Nature of Work: SUN ROOM

**CITY OF SACRAMENTO DEVELOPMENT SERVICES DIVISION
PLANNING AND ZONING INFORMATION REQUEST**

Description of Request/Proposed Use addition of sun room

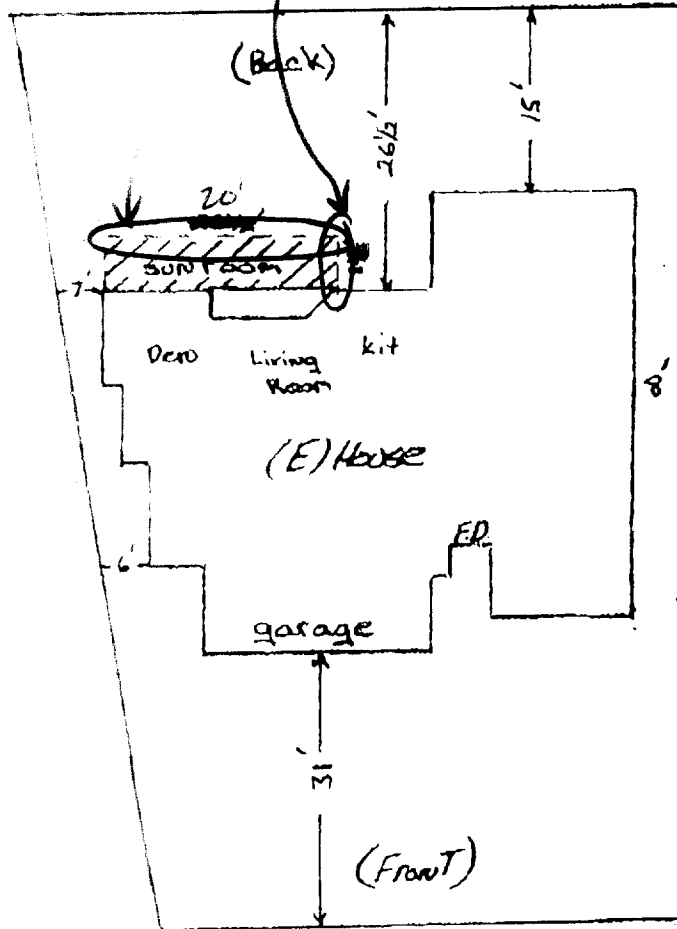
65% MIN. OF WALL AREA MUST HAVE READILY REMOVABLE PLEXI-GLASS OR GREEN

Comments: setbacks are OK; based on number in Met. cal., addition appears to exceed lot coverage (approx. 42%) must provide a more accurate, more detailed base plan/plot plan of property to confirm.

* Applicant has agreed to reduce size to 8' x 20' (160sq ft) which brings lot coverage down to 40%; no additional sq. ft allowable.
